# GROTTO ENGINEERING ASSOCIATES, LLC

April 26, 2024

Subject: Completeness Review No. 3  
Home & Land Development Corp.  
14 & 32 North Peak Street  
Block 35, Lots 8 & 9  
Borough of Highlands, Monmouth County, New Jersey  
Our File No.: PR-0290

1. HLPB2022-10 - COMPLETENESS REVIEW #3 – (February 20, 2024) – Carmela Roberts, P.E., C.M.E., C.P.W.M., Land Use Board Engineer

**SANITARY PLAN AND PROFILE**

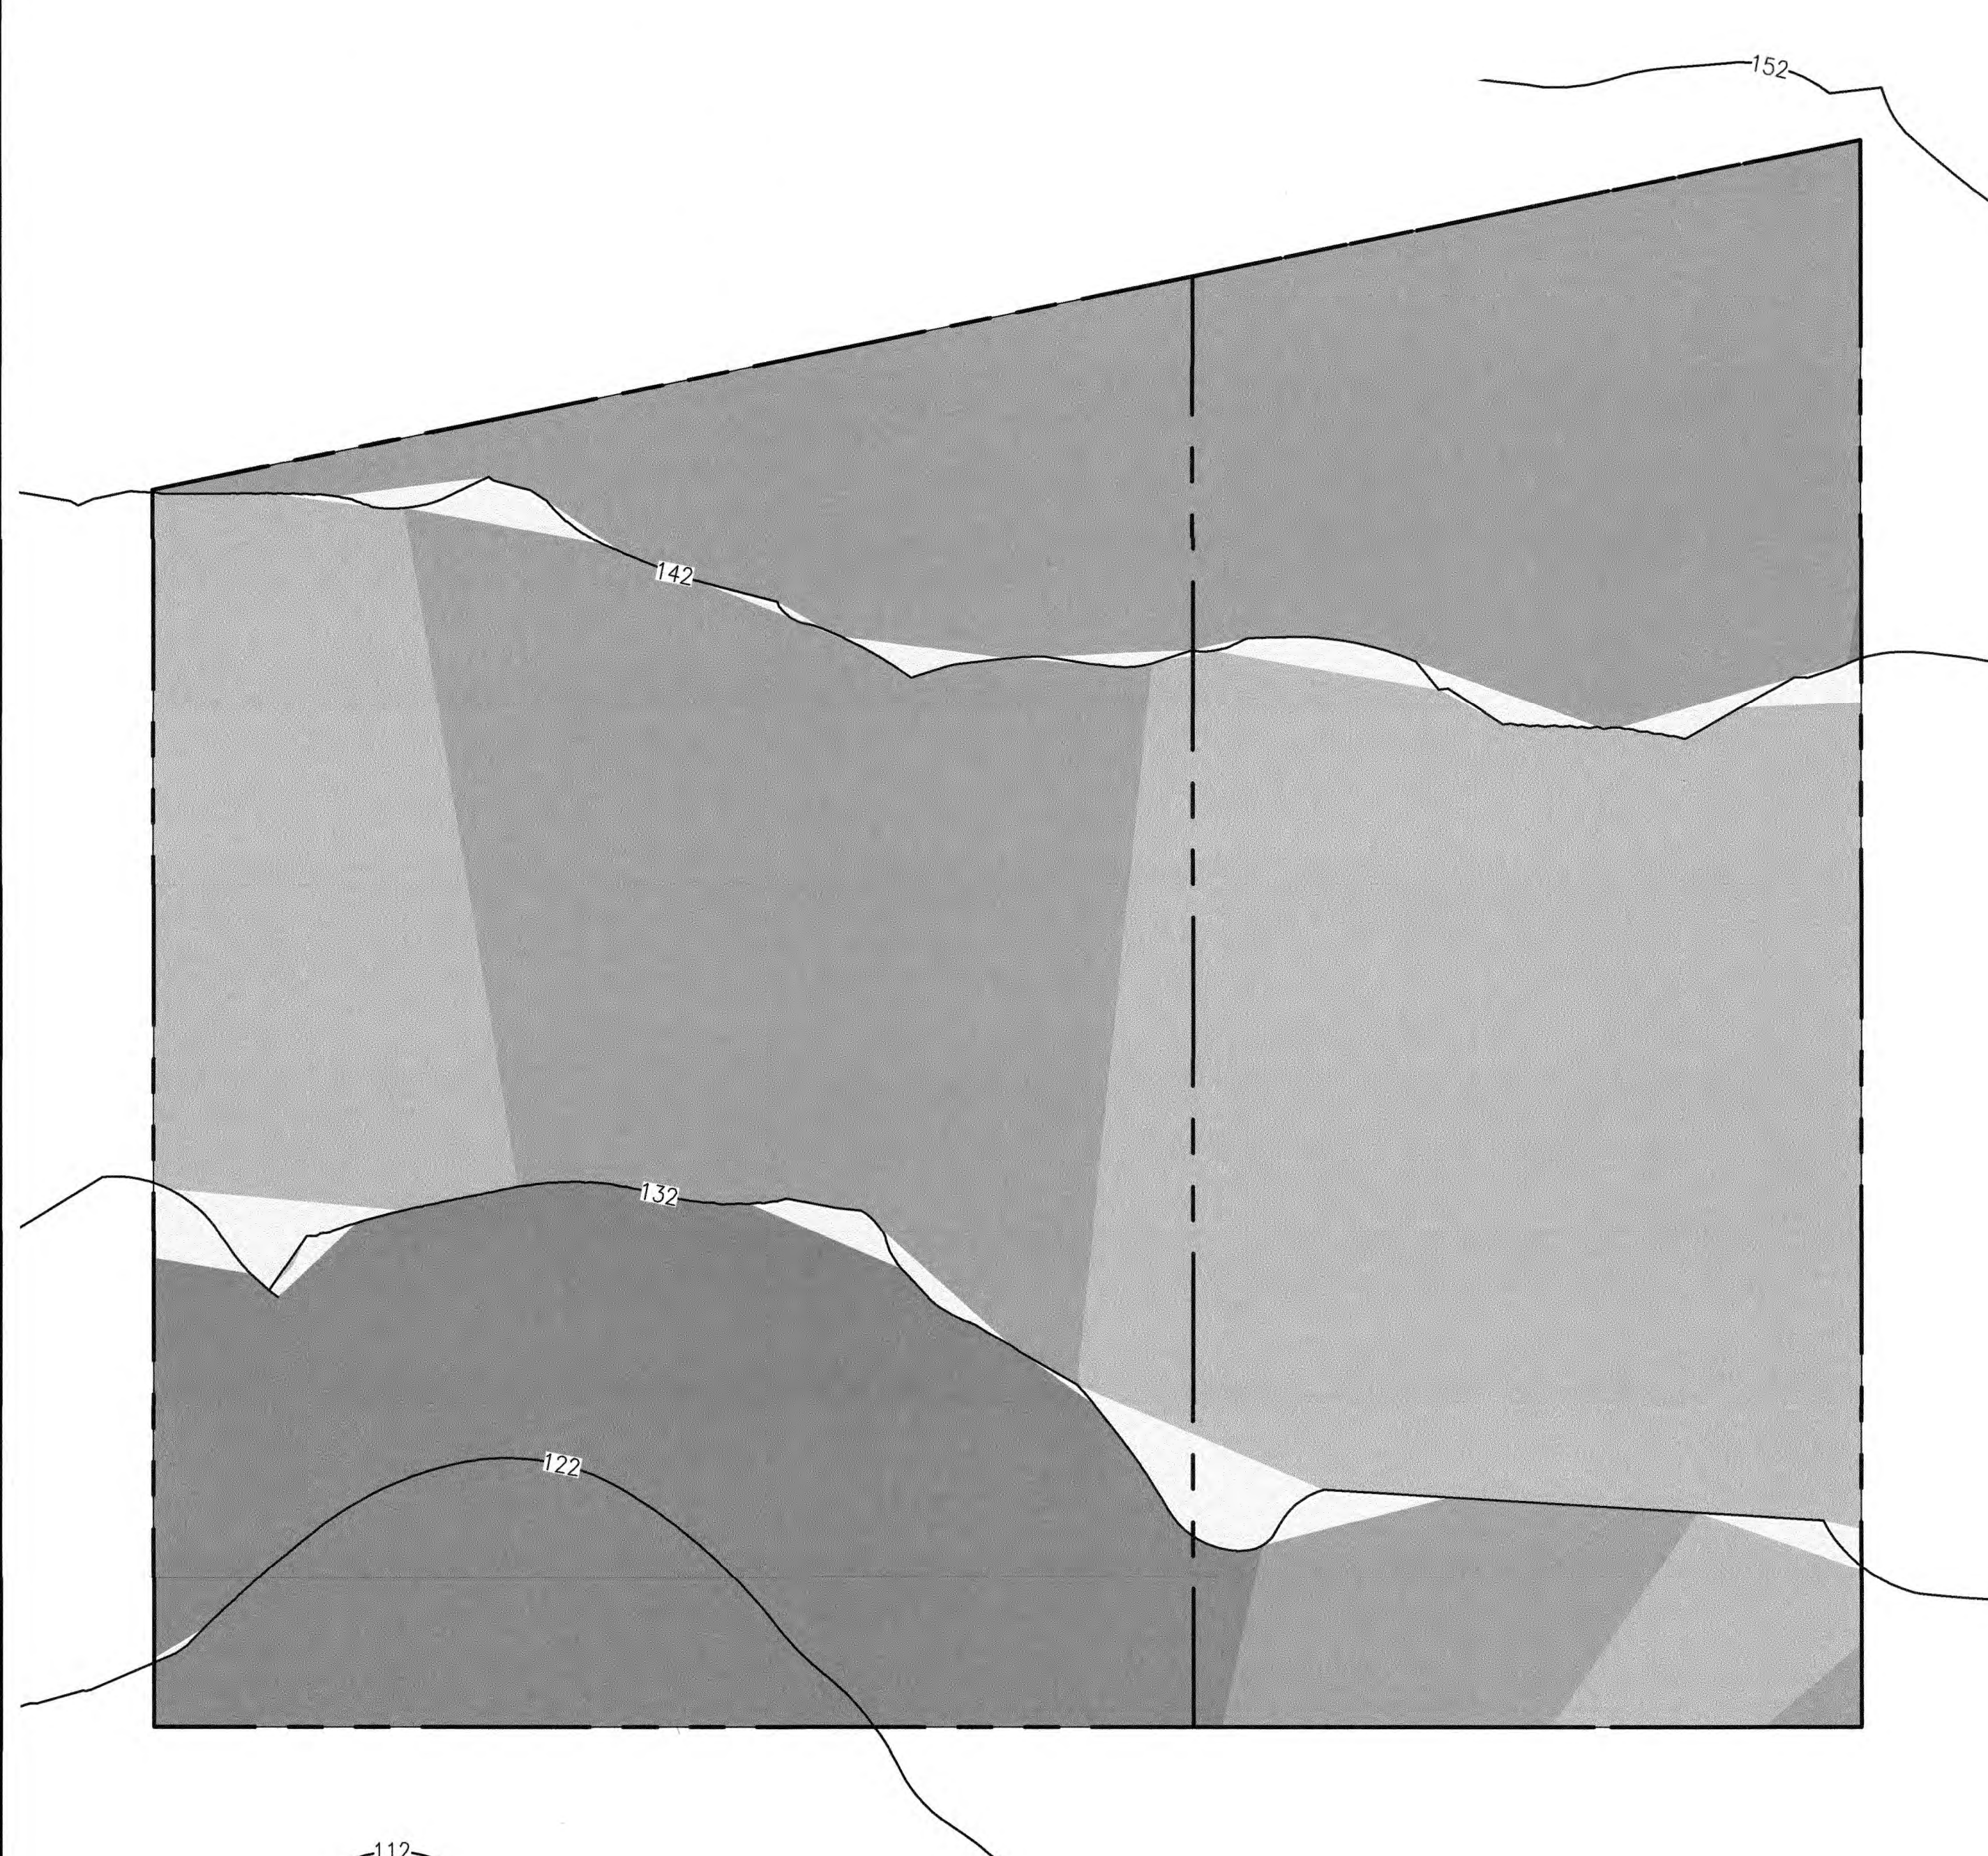
- f. It is presumed that the proposed dwellings will have to connect into the Borough's sanitary sewer system located in Valley Avenue. The applicant shall review and identify their proposed method of connection, which may involve use of the 10' right of way previously mentioned.

The Applicant proposes to provide 4-inch lateral connections to the rear of the dwellings to the 10 ft right-of-way. A 6-inch sanitary sewer line will be constructed within the 10 ft wide right of way and connect to an existing sewer manhole located on Valley Avenue. A profile of the lateral connection from the proposed dwelling to the manhole connection on Valley Avenue is required to demonstrate acceptable coverage, depths, and slopes. As noted in Comment D, the applicant shall provide evidence regarding title to the 40 ft. wide right of way, and under what authority they propose to install said improvements.

**A profile of the lateral connection from the proposed dwelling to the manhole connection on Valley Avenue has been provided on sheet 4 of 8. Monmouth county 2' contours were used for areas not within the surveyed information.**

**SLOPE ANALYSIS PLAN**

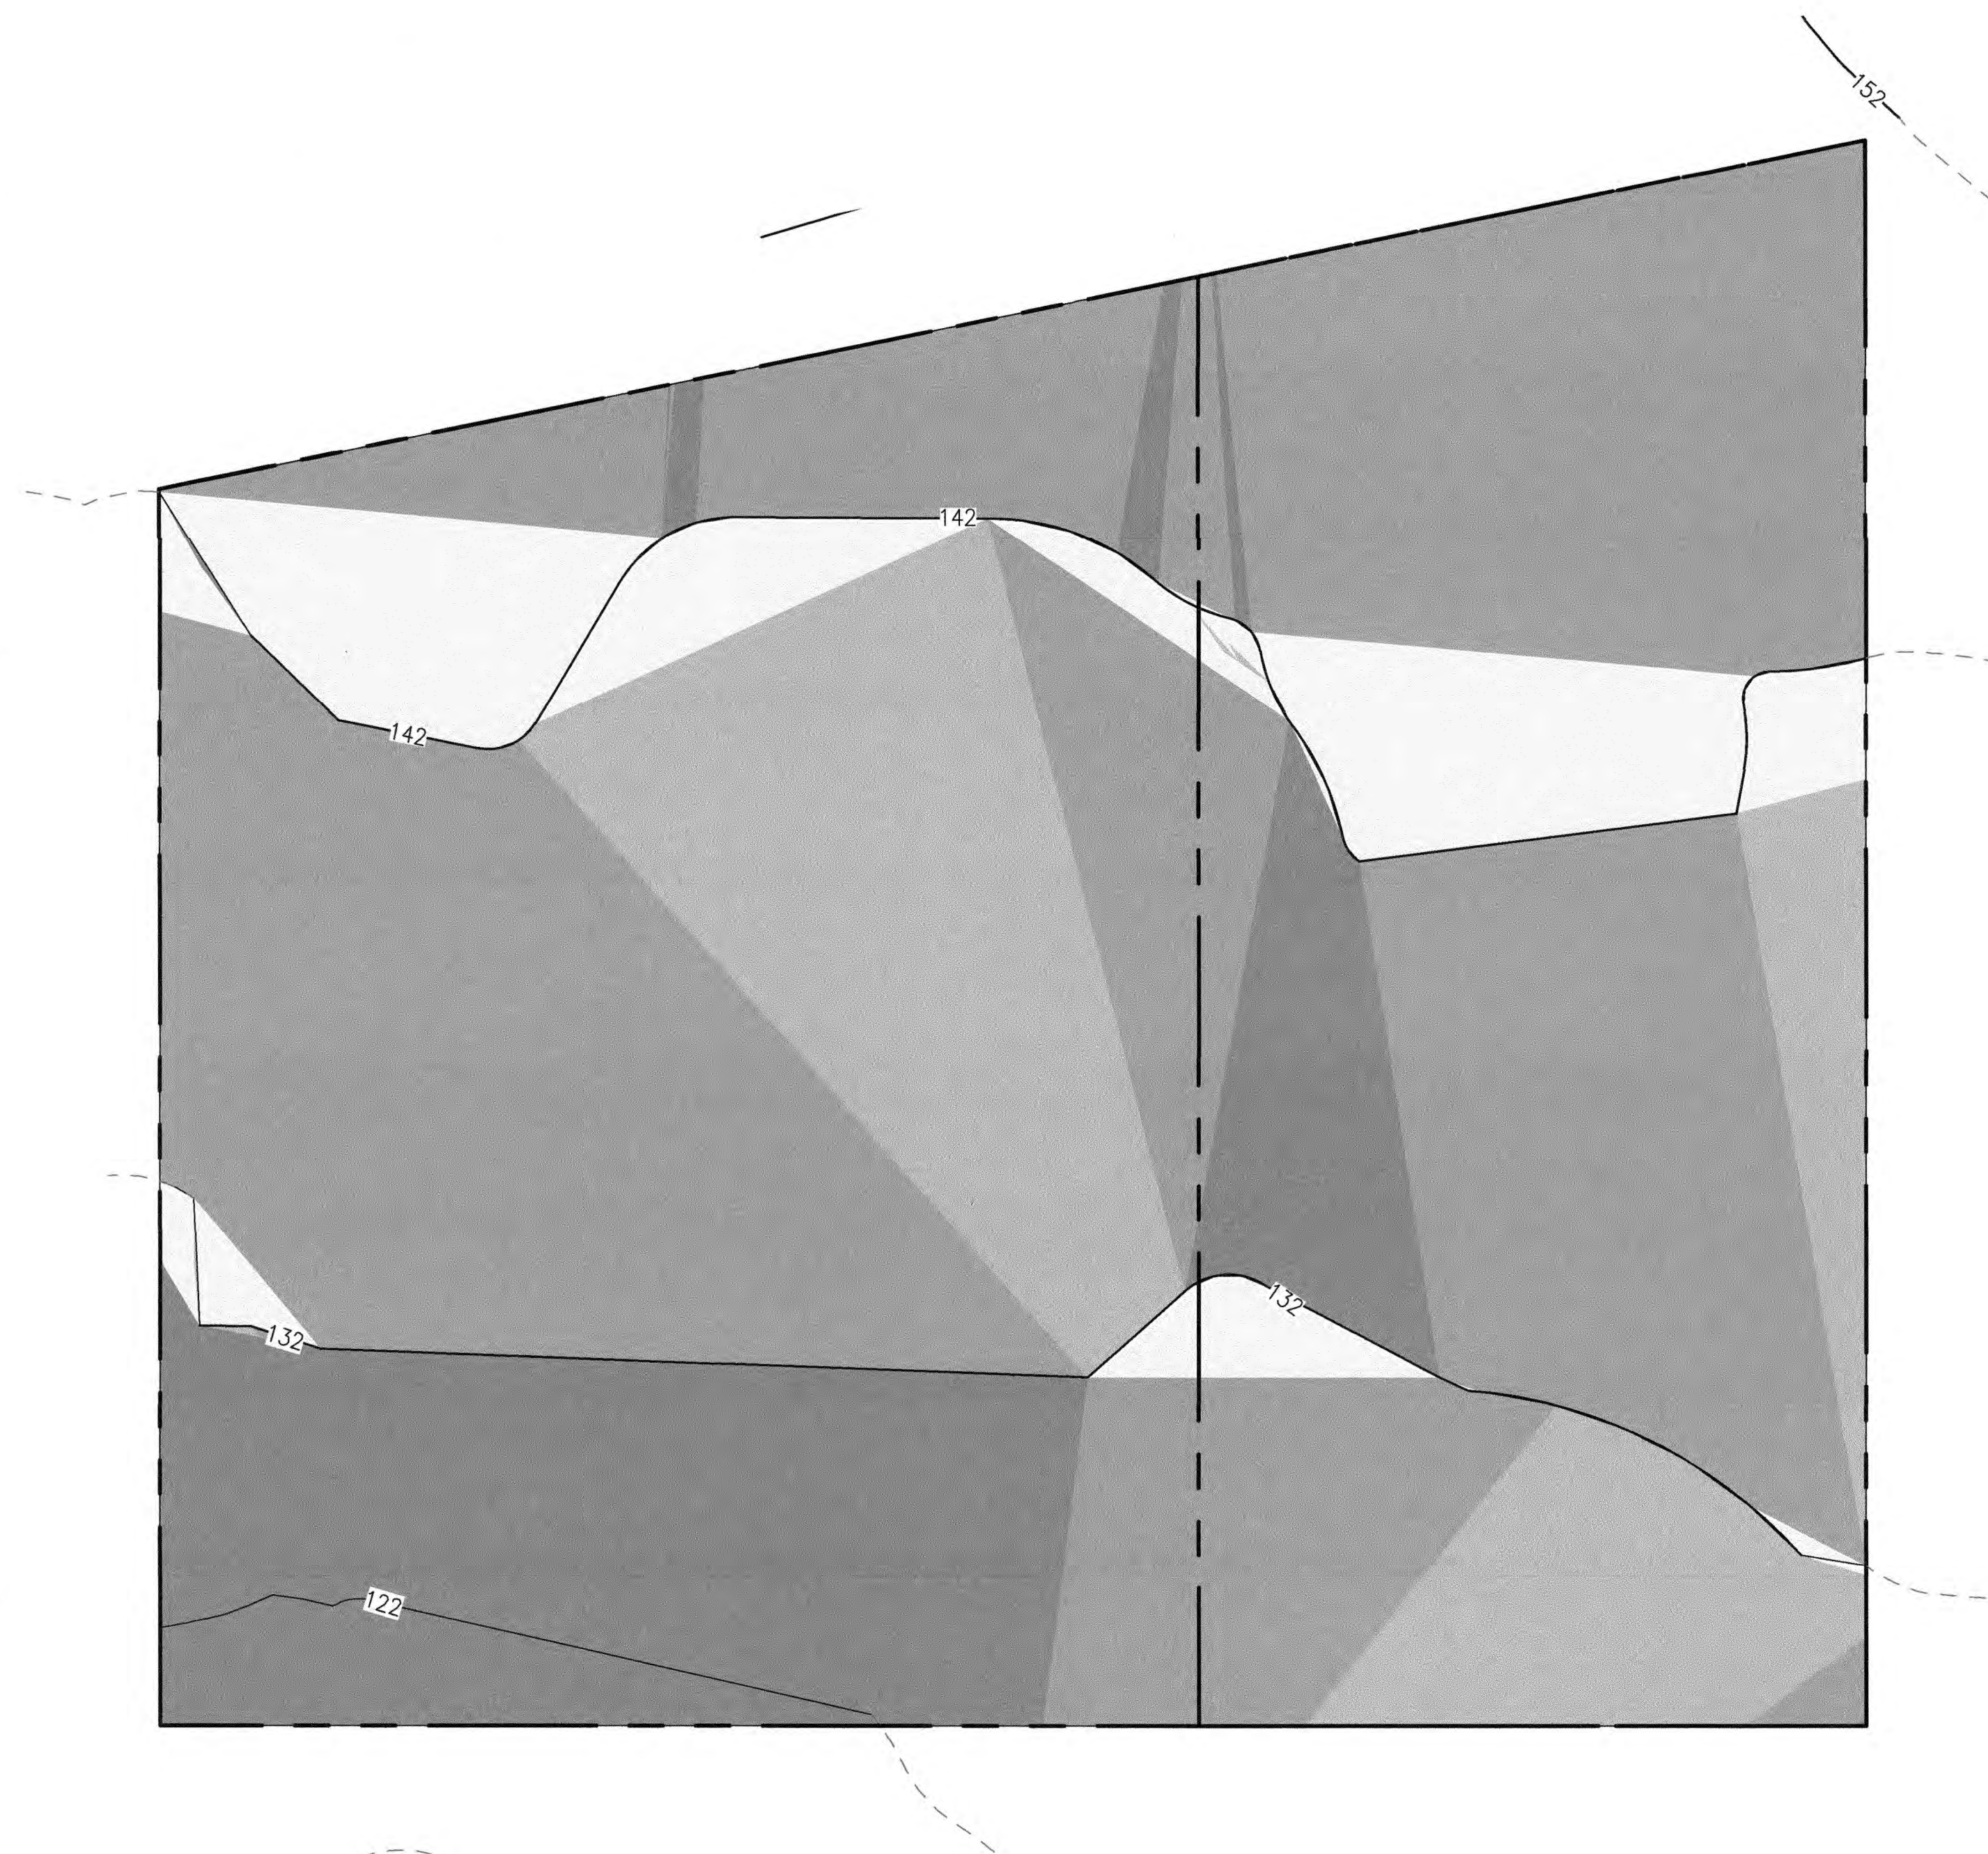
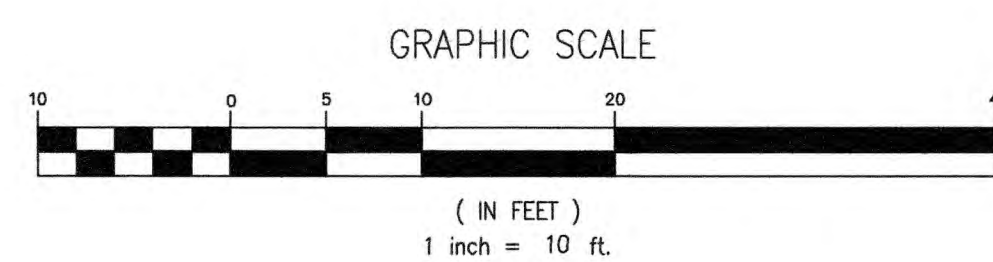
The Applicant is requested to provide a slope area calculation table noting existing and proposed areas of slopes per criteria. The analysis for the Slope Ordinance not only pertains to the subject property but also 100 ft from the boundary of the property. There are slopes greater than 15% as shown on Sheet 2 and the proposed front yard grading on Sheet 3.

**This office has prepared a slope analysis plan, see sheet 5 of 8. Additionally, Stormtech (SC-740) Chamber Systems will be installed in the rear yards of each property. The chambers will temporarily store roof runoff during a storm event to control the stormwater runoff. The bottom of the chambers are open and are installed on clean stone which allows the stored water to percolate into the ground. Roof leaders will be hard piped directly to the chambers. Details, size, and specification may be provided upon request.**
